**Re: Defect Information Report – Supplemental Report No. 2
10E-005 (10C-2) & 10V-112 (FL-575), S60 DPF Over Temp Shutdown**

Subject: **Safety Recall 10C2**
Series 60 EPA07 MCM Reprogramming in Fire Truck Applications

SAFETY RECALL BULLETIN

Figure 1 – Software and Fuel Map Version Number

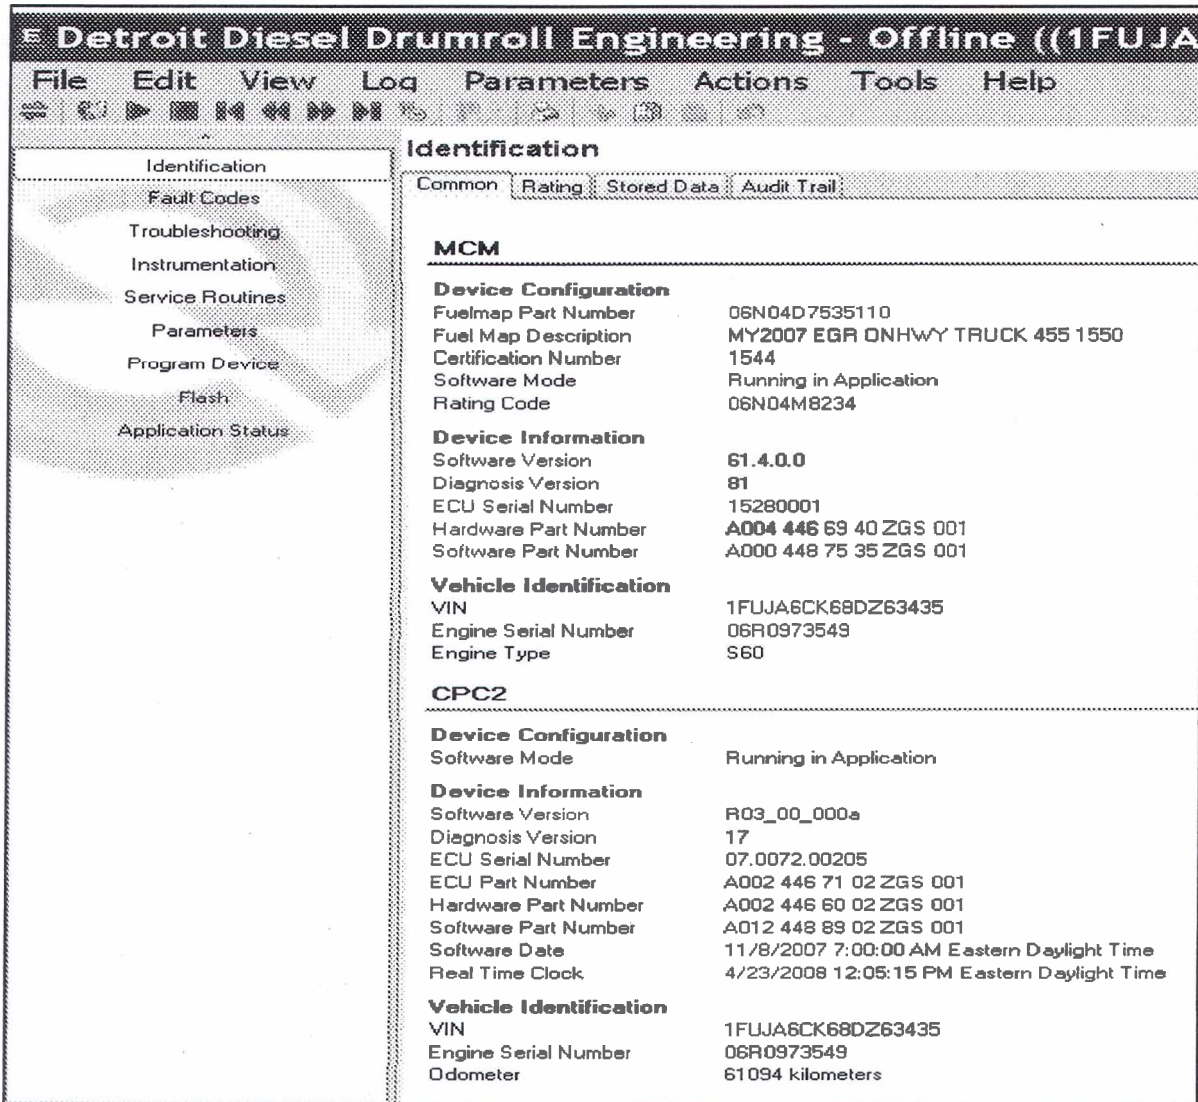
4. If the MCM is not at software v62.6.0.0 with fuel map version 114 or higher, program it to v62.6.0.0 or higher using the "Update Device Software" option. Select "No Charge", then "Description", and enter "10C2" in the "Provide Reference" box.
5. Using the "Identification" screen in DDRS 7.04, check the CPC software level. See Figure 1. In this example, the CPC software level is r3.00. If the CPC is not at r4.03 software or higher, program it to r4.03 using the "Update Device Software" option. Select "No Charge", then "Description", and enter "10C2" in the "Provide Reference" box.
